Cleanup Action Plan Addendum

Riverside HVOC Site

Prepared for
City of Bothell

February 2025 DRAFT

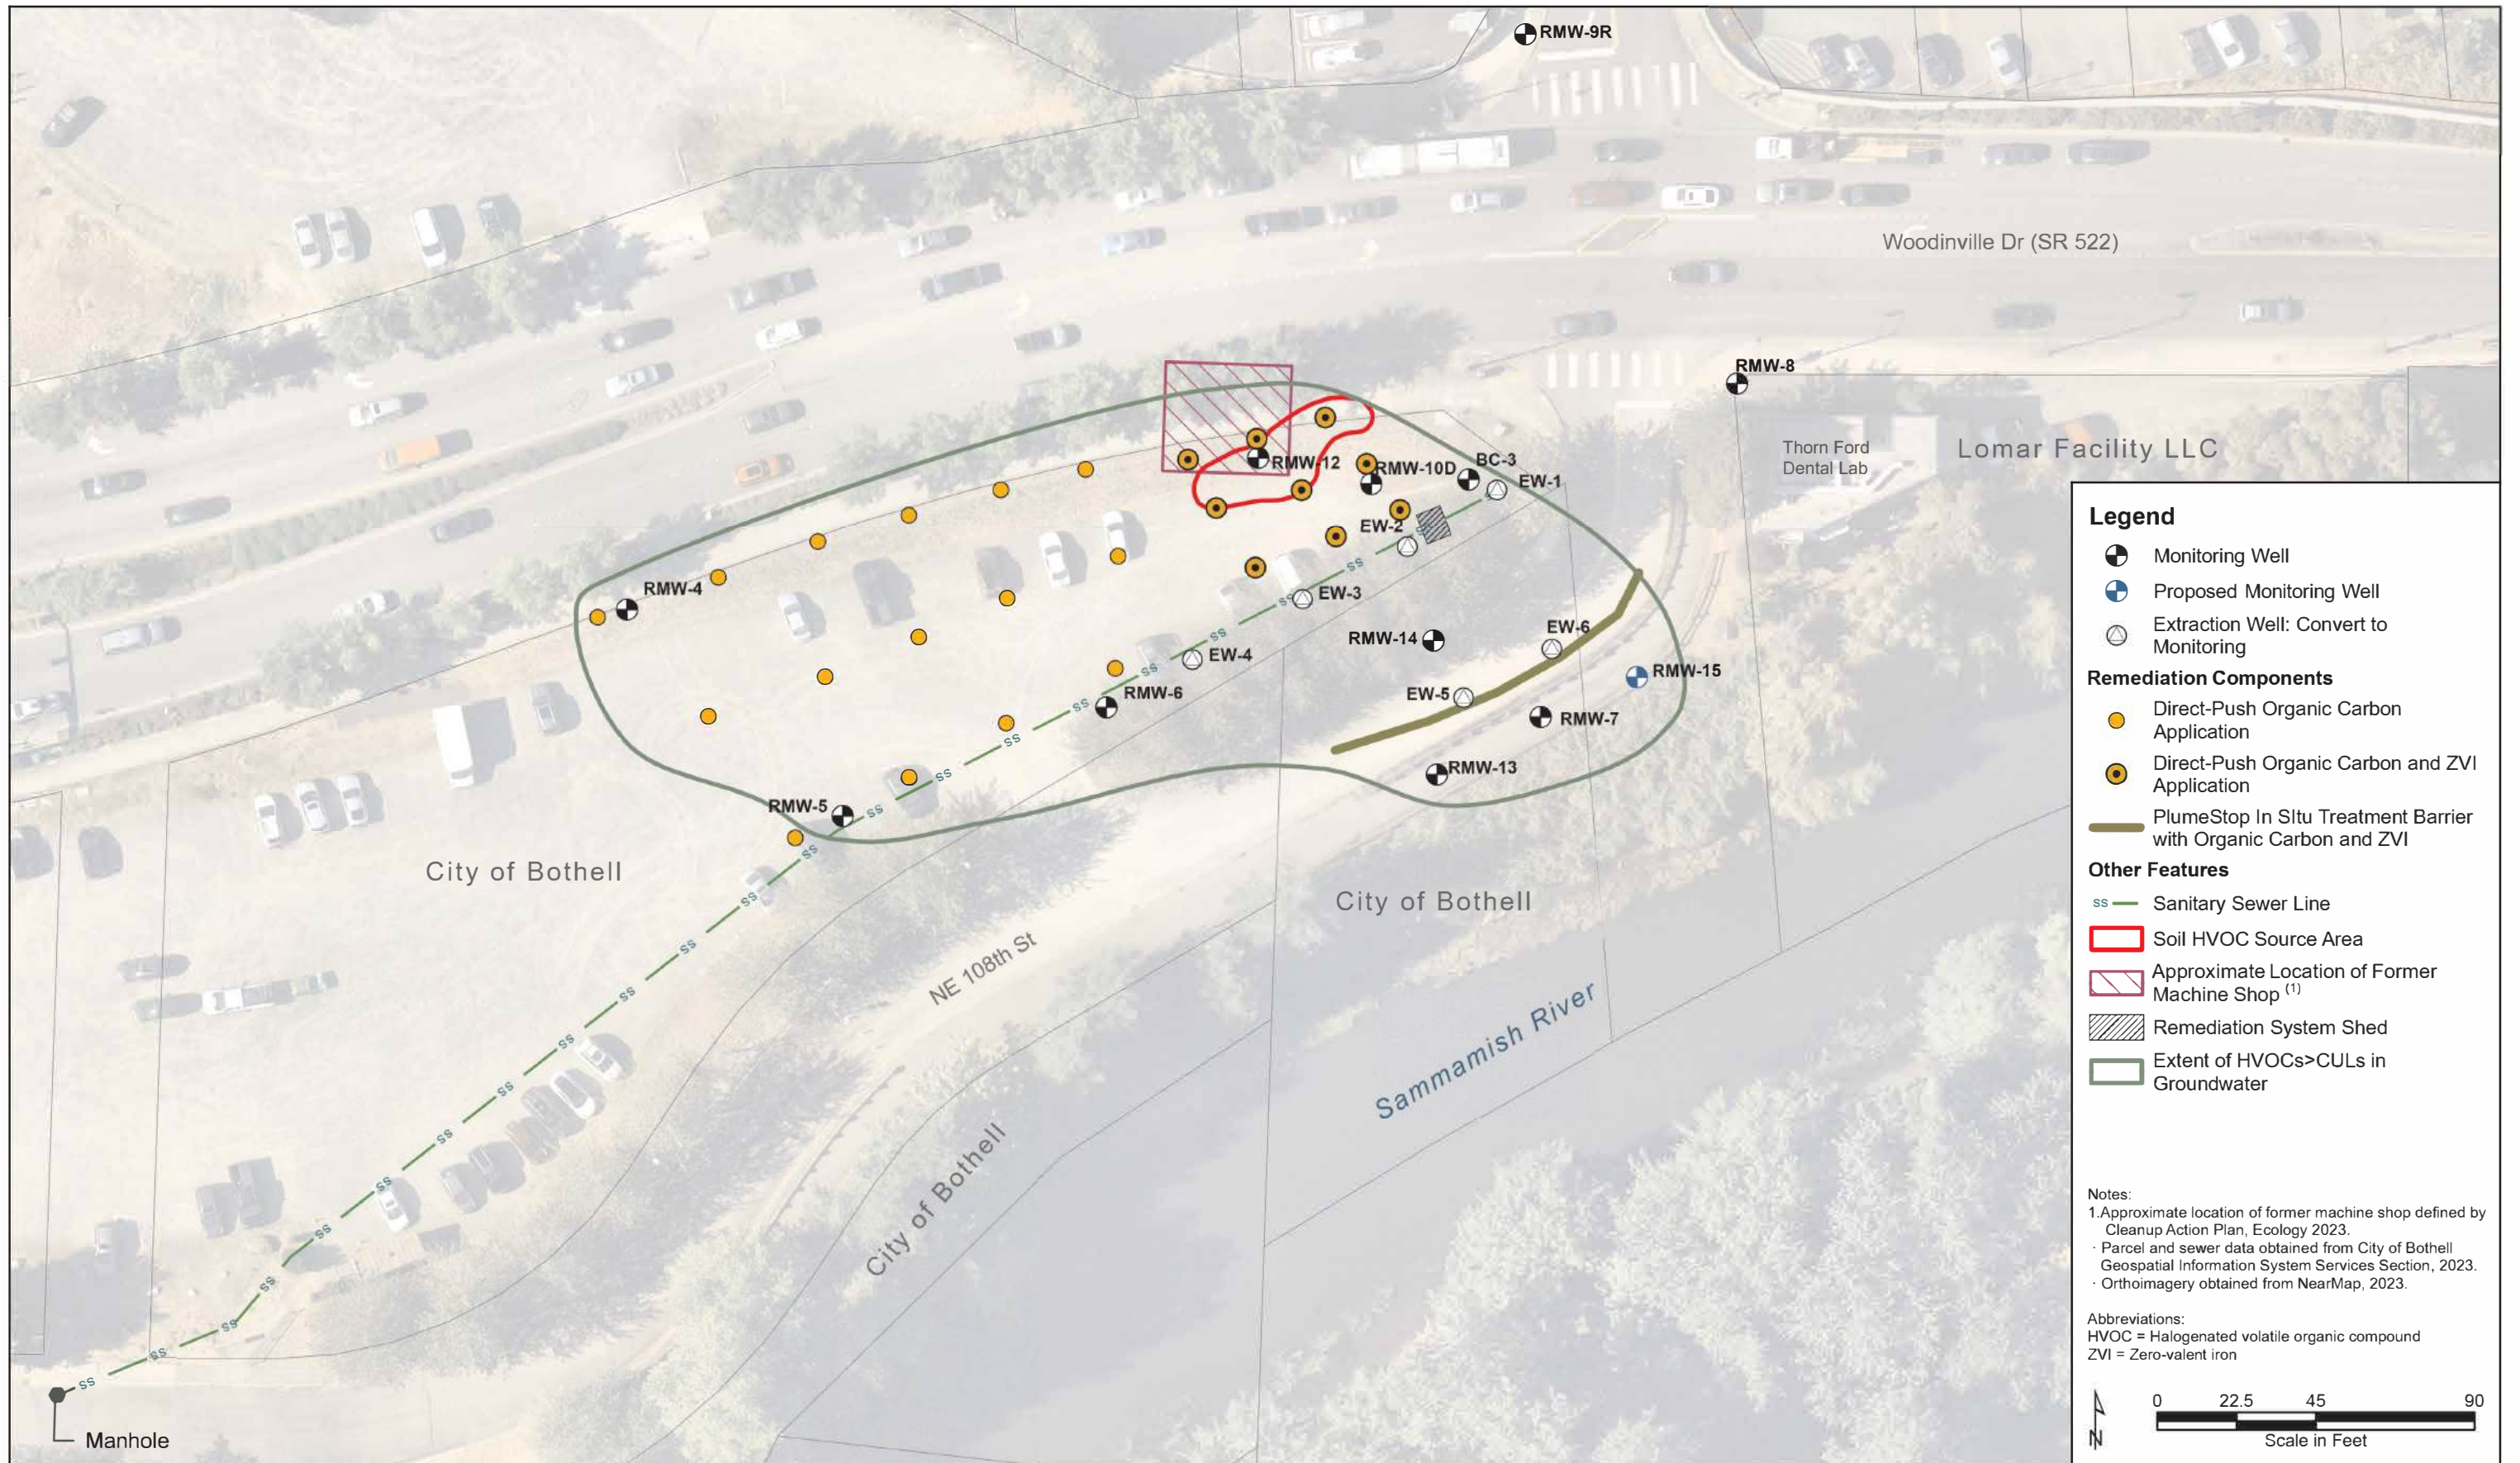
The 2023 CAP cleanup action includes SVE and Site-wide recirculation of groundwater amended with a soluble organic carbon substrate electron donor (CarBstrate™) to enhance biodegradation of HVOCs (Ecology 2023). The elements of the 2023 CAP cleanup action are shown on Figure 3.1, which is reproduced from the CAP.

- 12 soil vapor extraction wells
- Vapor collection piping and blowers and a vapor treatment system to remove HVOCs prior to discharge
- Six injection wells and two extraction wells (plus conversion of two existing extraction/monitoring wells for injection)
- Injection delivery and recovery piping, groundwater treatment system to remove remaining HVOCs prior to reinjection, and injection delivery control system

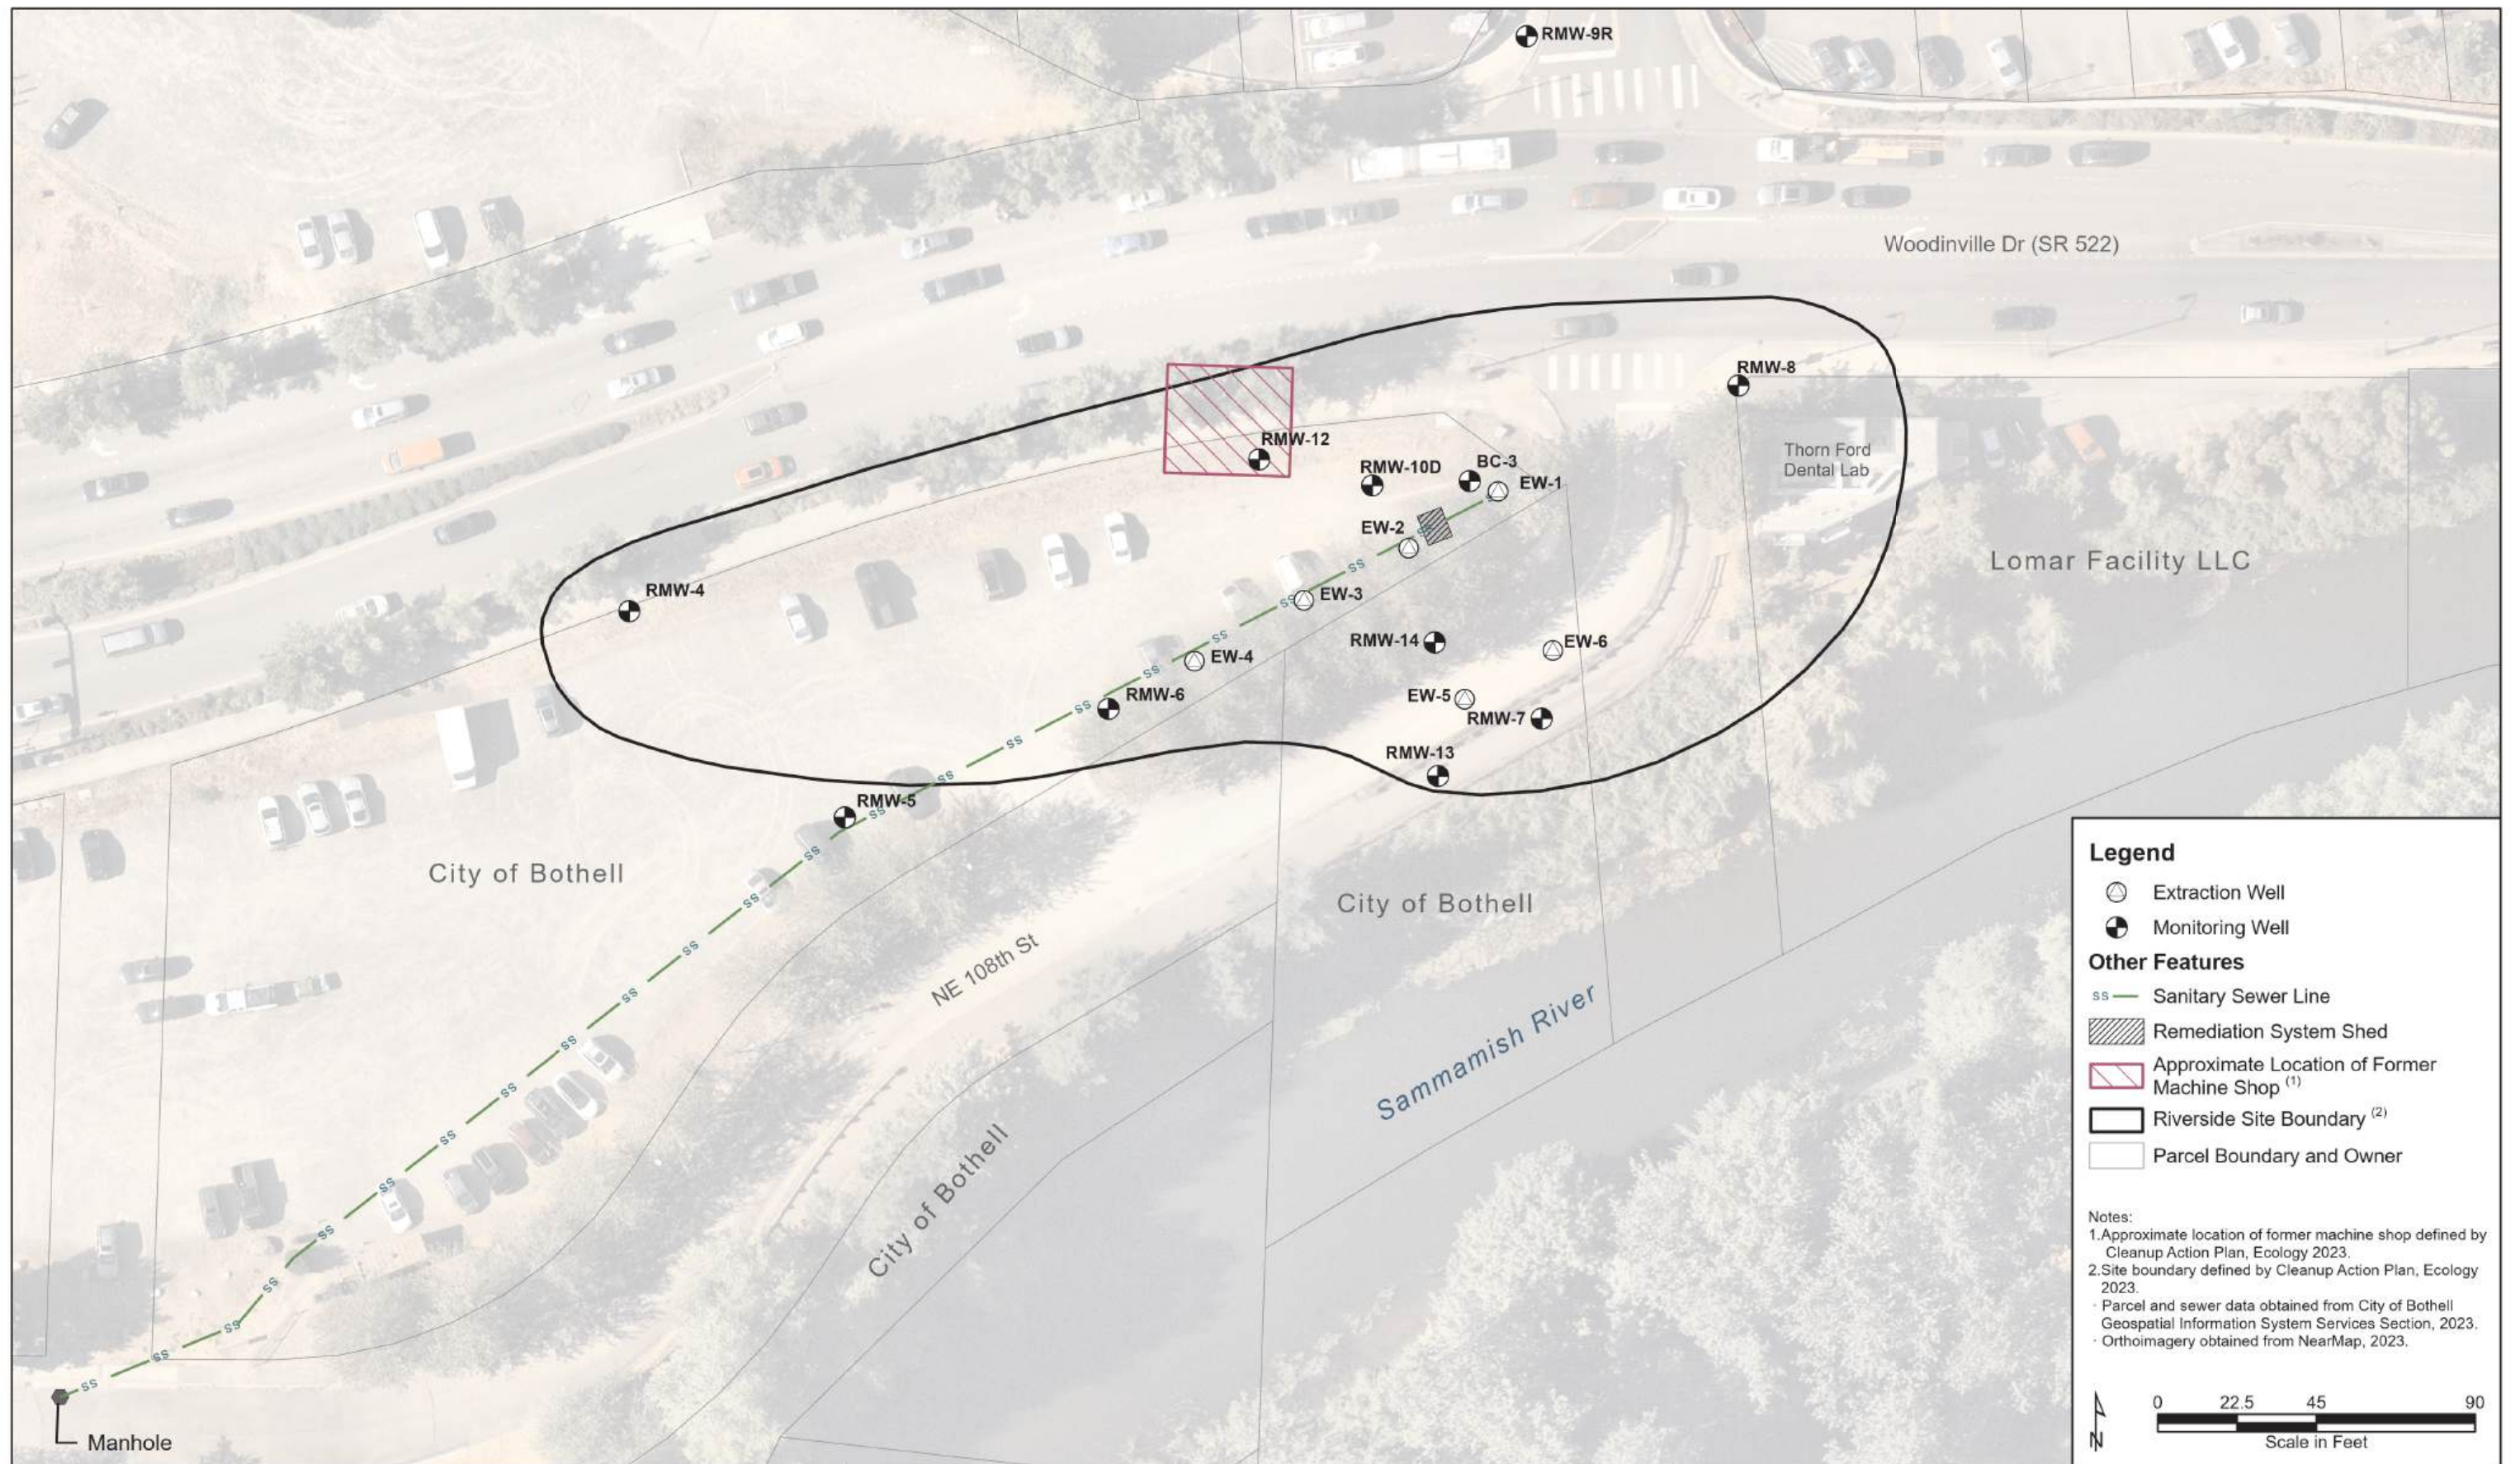
The 2024 PDI data indicate that vadose soil does not require treatment and that the remaining source contamination in saturated soil and groundwater is reduced from 2020 concentrations and is able to be treated with a single treatment event using direct-push drilling, instead of continuous injection, extraction, and recirculation treatment. The revised cleanup action makes the following adjustments to adapt the remedial action to current Site conditions based on the findings of the PDI:

- SVE is eliminated.
- Soluble organic carbon and *Dehalococcoides* treatment in the source area is achieved by direct-push injection, which is supplemented with zero-valent iron (ZVI). A lesser amount of supplemental ZVI is also added in the western plume.
- Downgradient soluble organic carbon and *Dehalococcoides* treatment are supplemented with ZVI and colloidal activated carbon (such as PlumeStop) to form in situ treatment barriers.
- A controlled-release source of organic carbon is used.

The elements of the revised cleanup action are shown on Figure 3.2. This alternative supplements source area treatment with ZVI to achieve prompt abiotic degradation of PCE and TCE and ensure ongoing reducing conditions to promote anaerobic biodegradation. The addition of ZVI, combined with a controlled-release form of organic carbon, allows for a single direct-push application of the treatment materials in lieu of recirculation to degrade the remaining HVOC mass. The addition of colloidal activated carbon downgradient is designed to adsorb HVOCs and allow longer contact time with the treatment materials, which will allow for more rapid cleanup of downgradient groundwater. A double row of injections is assumed in order to form a highly effective barrier. The estimated restoration time frame for this cleanup action is 3 years. The estimated cost for this cleanup action is \$1,655,362.

Based on the analysis described in the previous sections, Ecology has eliminated SVE treatment of vadose soil and revised the in situ groundwater treatment as shown on Figure 3.2 to address contamination in saturated soil and groundwater at the Site. This revised cleanup action will remediate contaminants in saturated soil and groundwater, treat contaminated groundwater flowing through downgradient in situ treatment barriers before reaching the Sammamish River, and protect human health and the environment at reduced cost and faster restoration time frame than the 2023 CAP cleanup action.
